Re: Case No. 20-1679-EL-BGN - In the Matter of the Application of Pleasant Prairie Solar Energy LLC for a Certificate of Environmental Compatibility and Public Need to Construct a Solar-Powered Electric Generation Facility in Franklin County, Ohio.

Response to Fourth Data Request from Staff of the Ohio Power Siting Board

**PLEASANT PRAIRIE SOLAR ENERGY LLC 'S
RESPONSE TO THE FOURTH DATA REQUEST
FROM THE STAFF OF THE OHIO POWER SITING BOARD**

Wells in Project Area Pleasant Prairie Solar Project Franklin County, Ohio

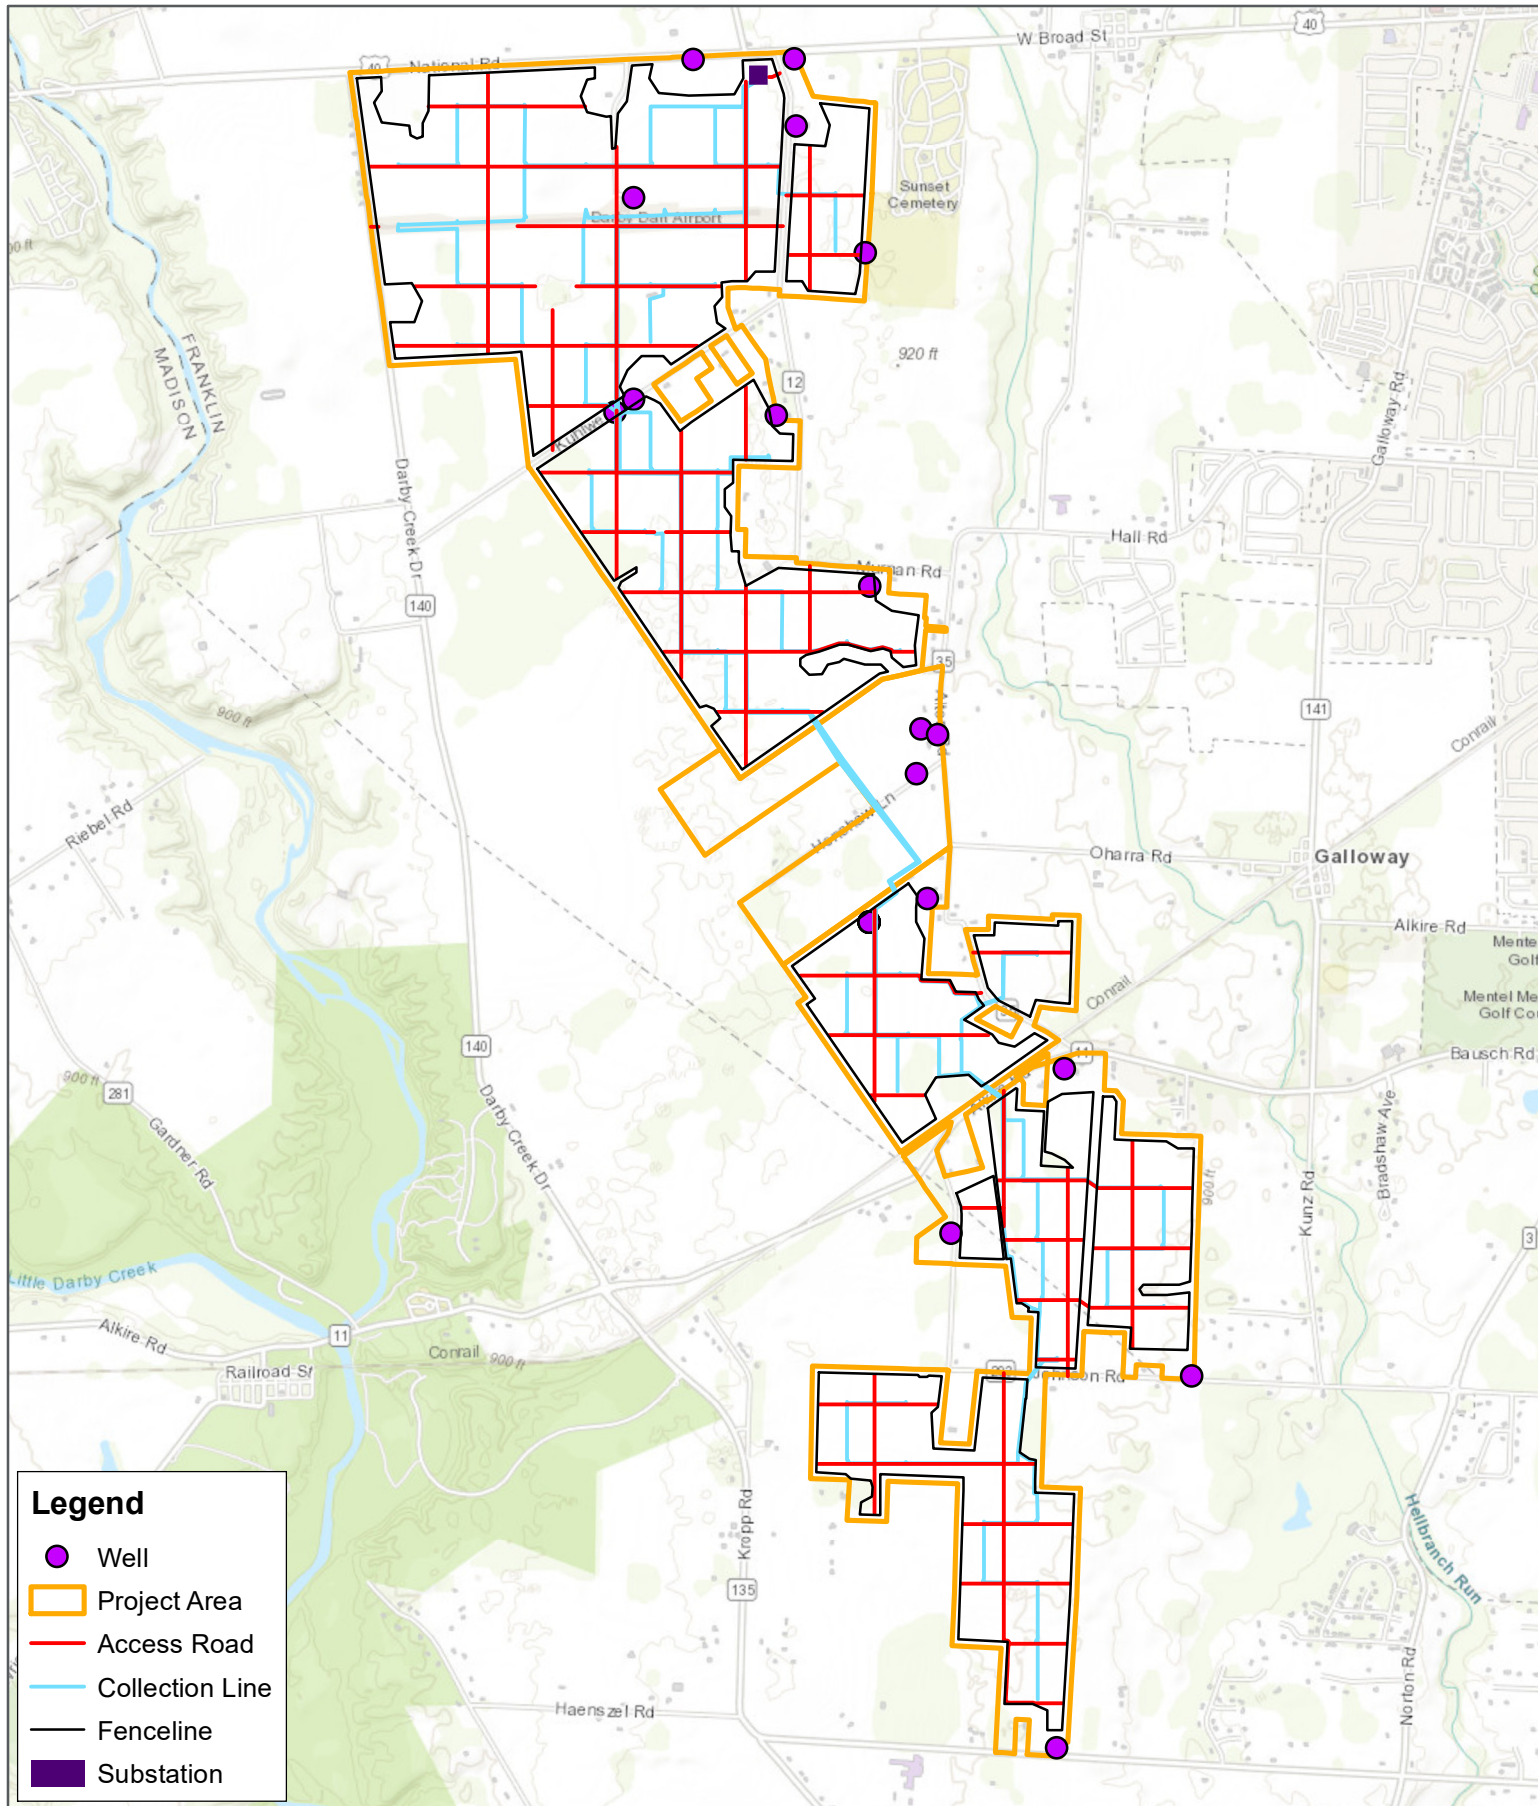
10. Please explain what possible avoidance, minimization, and/or mitigation measures Pleasant Prairie Solar Energy, LLC will employ during construction for water well locations in the project

Response: For local private well systems, these systems are typically located near residences and Project construction is not anticipated to physically damage private wells or affect well yields. Given that minimal excavation is associated with the Project and pile driving will only occur to depths of 10 to 15 feet below grade, the Applicant does not anticipate impacts to the water supply.

The table below identifies the 22 water wells within the Project Area. There are 7 wells (2 drinking wells and 5 monitoring wells) within the fence line of the Project. The table below identifies the approximate distance to the nearest infrastructure for wells within the fence line. Attachment 1 to this response is a Figure showing the wells within the Project Area and their relation to the planned Project infrastructure.
